# UNITED STATES PATENT AND TRADEMARK OFFICE

APPLICATION NO.	FILING DATE	FIRST NAMED INVENTOR	ATTORNEY DOCKET NO.	CONFIRMATION NO.
10/736,336	12/15/2003	Hyunjun Kim	P17176	3721
28062	7590	07/31/2006	EXAMINER	
BUCKLEY, MASCHOFF, TALWALKAR LLC			MAI, ANH T	
5 ELM STREET			ART UNIT	
NEW CANAAN, CT 06840			PAPER NUMBER	
			2832

<b>Office Action Summary</b>	<b>Application No.</b>	<b>Applicant(s)</b>	
	10/736,336	KIM ET AL.	
	<b>Examiner</b>	<b>Art Unit</b>	
	Anh T. Mai	2832

## DETAILED ACTION

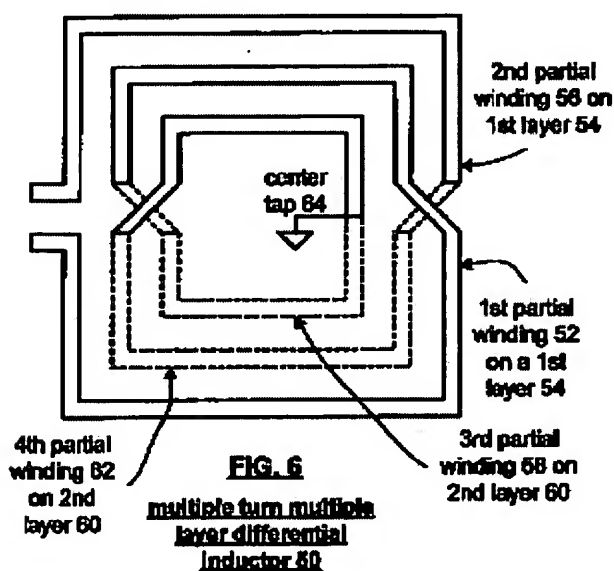
Wakamatsu discloses the invention as claimed as cited above except for the second portion of the inductor coupled at a plurality of locations to the first portion. Kyriazidou discloses a multilayer inductor having first portion of winding 12 on first layer 14 of integrated circuit, second portion winding 16 on first layer, third portion winding 18 on second layer 20 of integrated circuit; the first portion winding 12 connected to third portion winding 18 by interconnecting 24, second winding portion 16 connected to fourth winding portion 22 by interconnecting structure 24; an imaginary vector normal to a first section of the inductor 52 on a first layer 54 will not intersect any other section of the inductor [figure 6; col 5, lines 32-39]. At the time of the invention, it would have been obvious to a person of ordinary skill in the art to use the multiple layer inductor as taught by Kyriazidou to the inductor as disclosed by Wakamatsu. The motivation would have been to minimize the use of integrated circuit real estate, operates at high frequencies and has a relatively high Q factor [col 4, lines 65-68]. Therefore, it would have been obvious to combine Wakamatsu with Kyriazidou.

With respect to claim 3, current is to flow in the first direction in the first portion and second direction in second portion opposite to the first direction [figure 3].

With respect to claim 6, Kyriazidou discloses vias 24 coupled the first and second portions.

With respect to claim 7, Wakamatsu discloses pin holes 9 coupled the first and second portions.

With respect to claim 8, dielectric layer 7a disposed between first layer and shielding plane and layer 6a disposed between second layer and shielding plane.

Applicant argues that the art of record is not seen to disclose or suggest a vector normal to a first section of an inductor that does not intersect any other section of the inductor as shown in figure 4 of Kyriazidou. The examiner strongly disagrees. As shown in another embodiment of Kyriazidou of figure 6, if a vector is drawn normal to any point of any sections 52, 56, 58, 62, it does not intersect other sections of the inductor.
